W-6 UPPER SEGMENT: HWY 90 TO SW MILITARY DRIVE SEWER MAIN PROJECT
Solicitation Number: CO-00317
Job No.: 19-4519

ADDENDUM 5
March 27, 2020

**SANITARY SEWER PLAN &
PROFILE LINE H AND LINE
I**

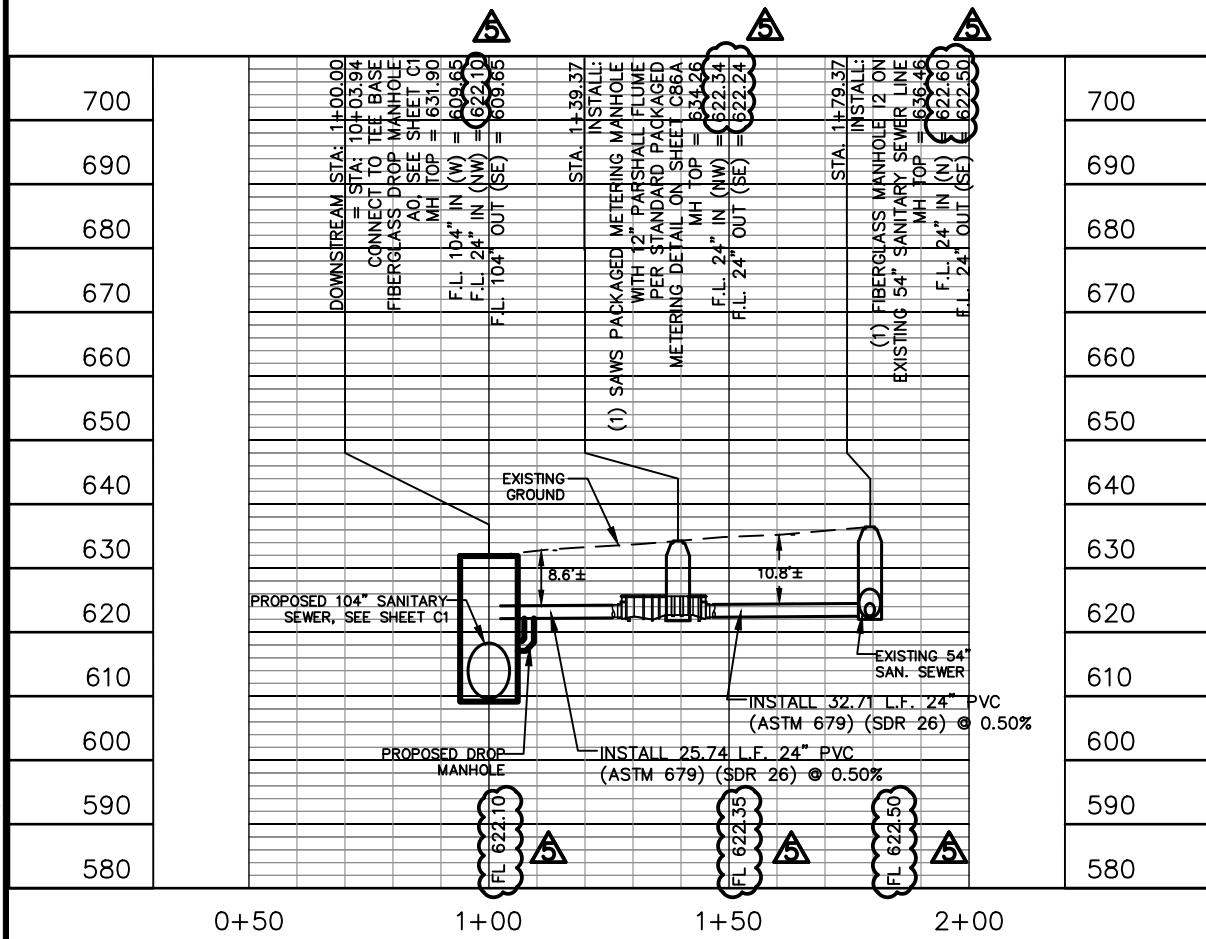
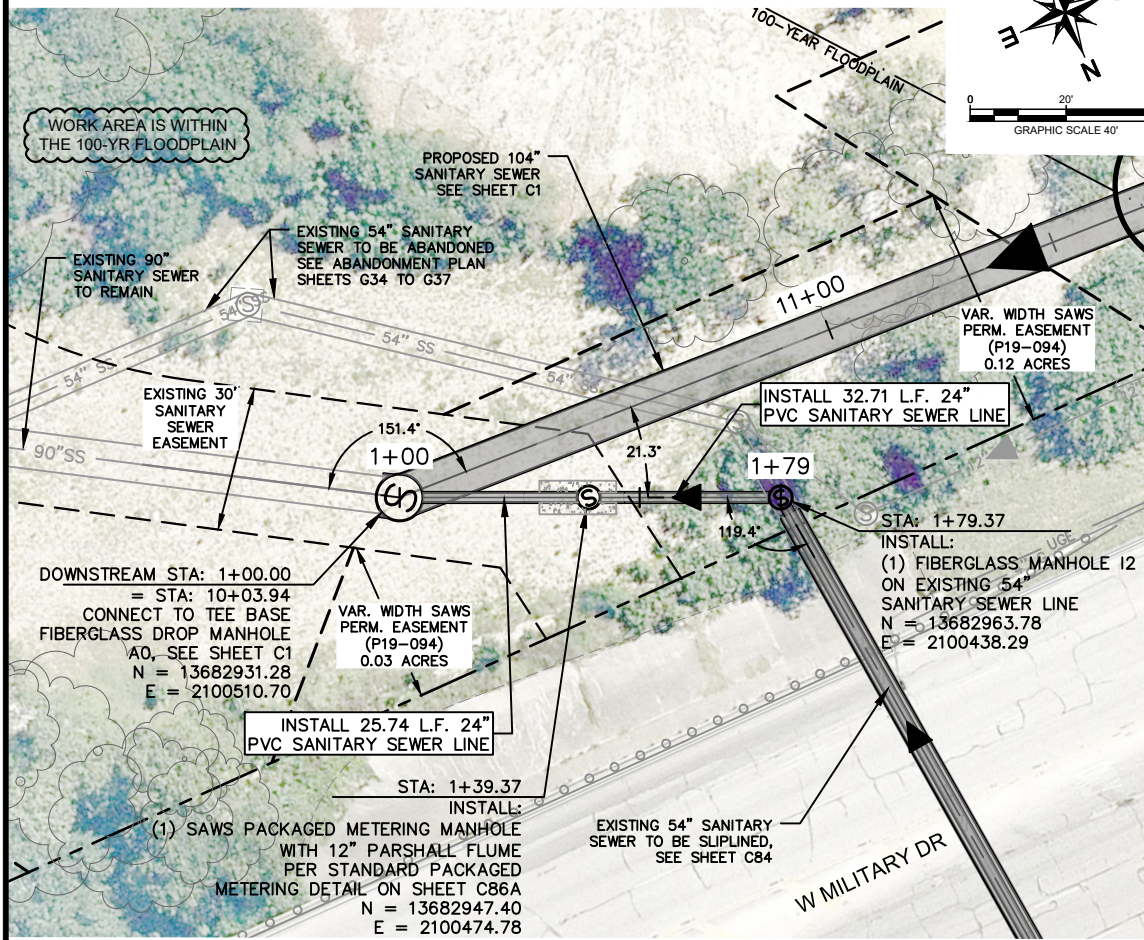
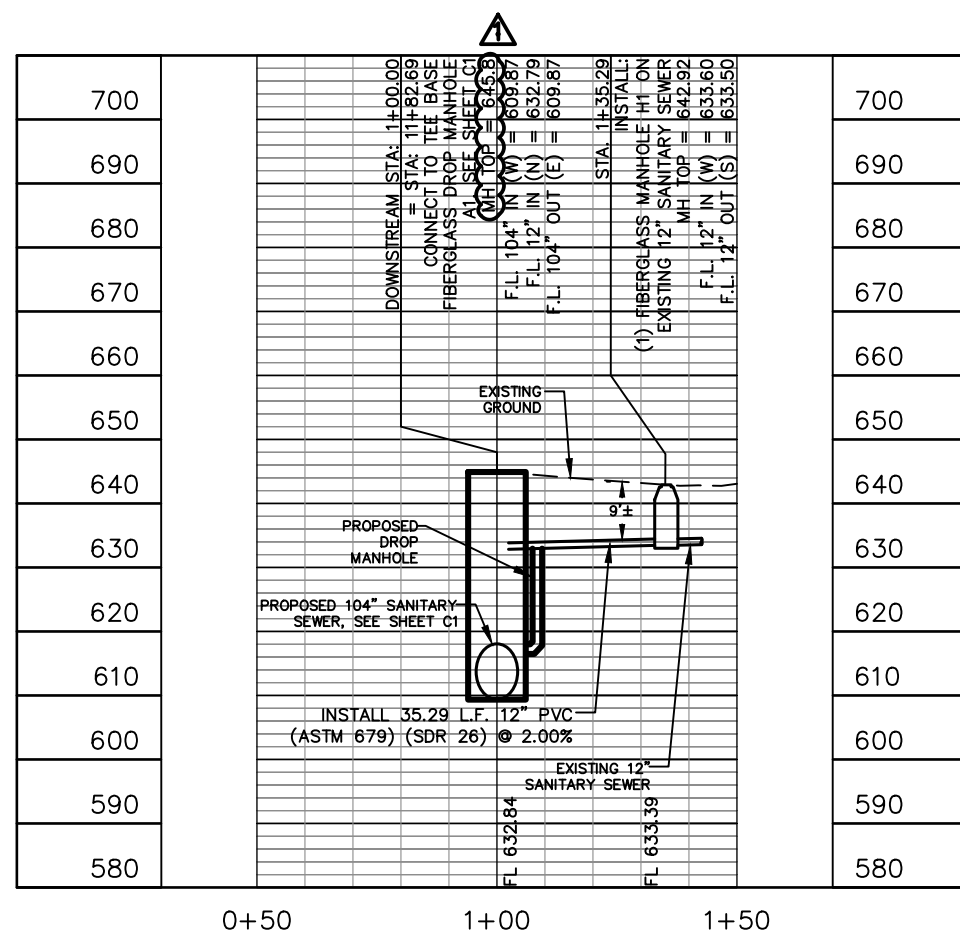
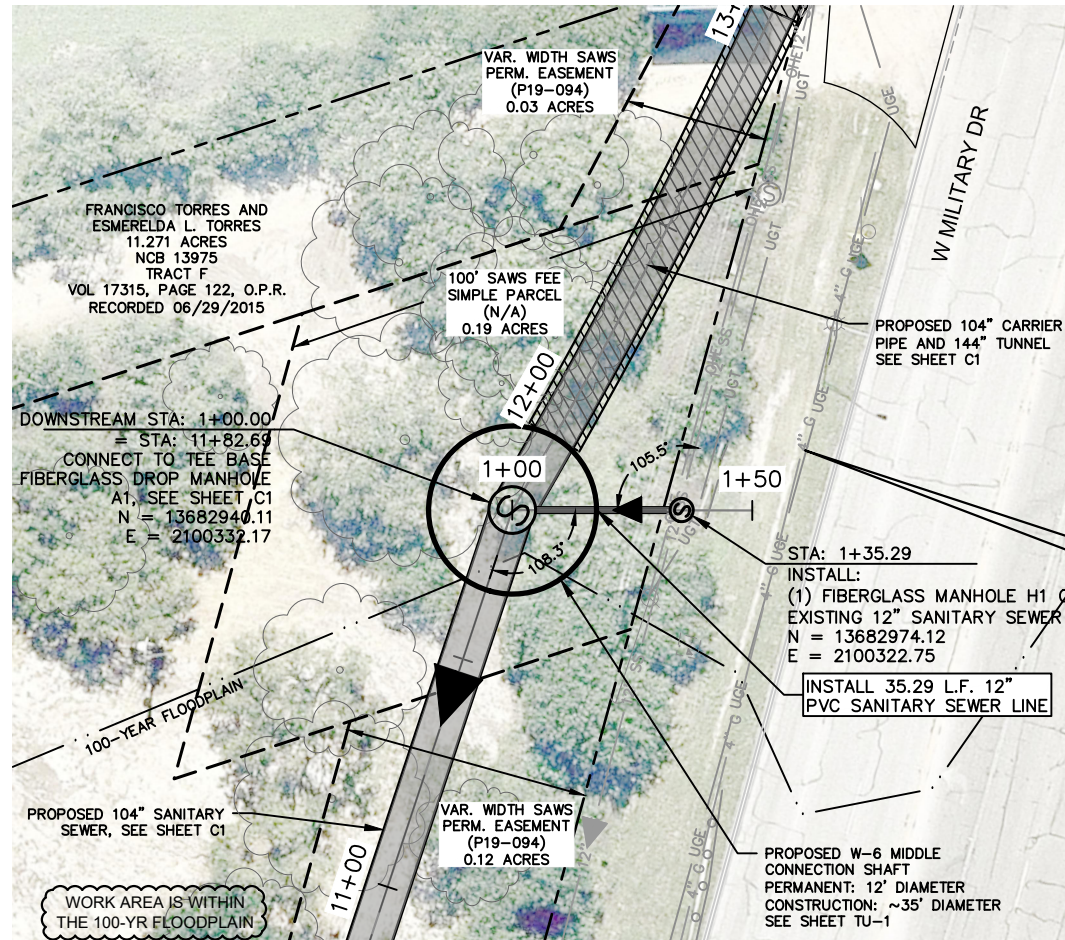
9. Sheet C83 – SANITARY SEWER PLAN & PROFILE LINE H AND LINE I – Revise and replace sheet in its entirety.
 - In the Estimated Quantities box, replace the quantity for Item No. 848A, 24-Inch PVC Gravity Sanitary Sewer Pipe (ASTM F679) (6’ – 10’ Depth) “ 37.89” with the following: “3.69”

PROPERTY OF SAN ANTONIO WATER SYSTEM SAN ANTONIO, TEXAS	MODIFIED TEE - BASE FIBERGLASS MANHOLE	APPROVED	REVISED
		AUG 2019	
DD-852-11		SHEET 1 OF 1

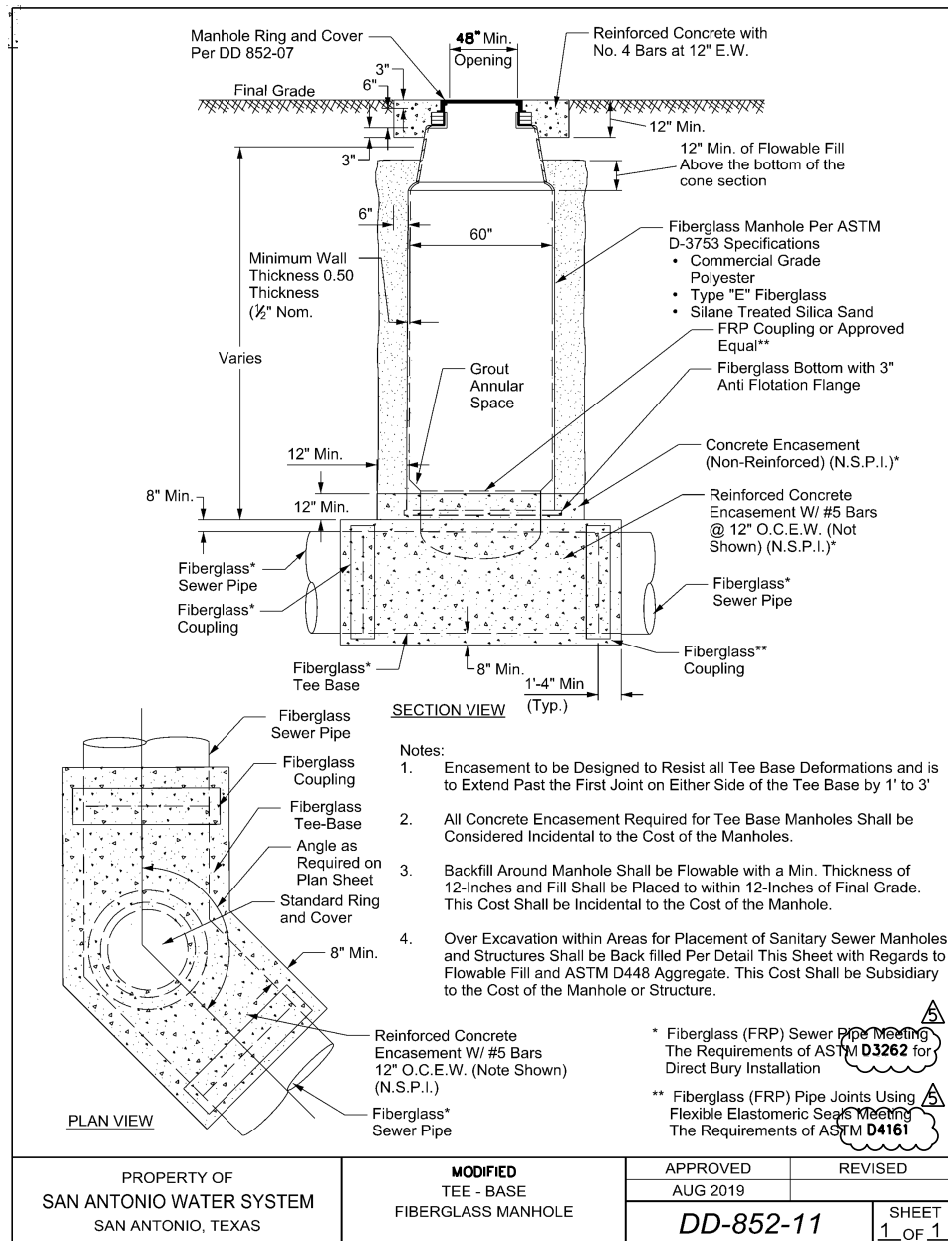
- Replace sheet title “C86 SEWER GENERAL DETAILS (SHEET 1 OF 3)” with the following: “C86 SEWER GENERAL DETAILS (SHEET 1 OF 4)”.
 - Replace note in the detail for Modified Tee-Base Fiberglass Manhole “Fiberglass (FRP) Sewer Pipe Meeting The Requirements of ASTM D3743 for Direct Bury Installation” with the following: “Fiberglass (FRP) Sewer Pipe Meeting The Requirements of ASTM D3262 for Direct Bury Installation”
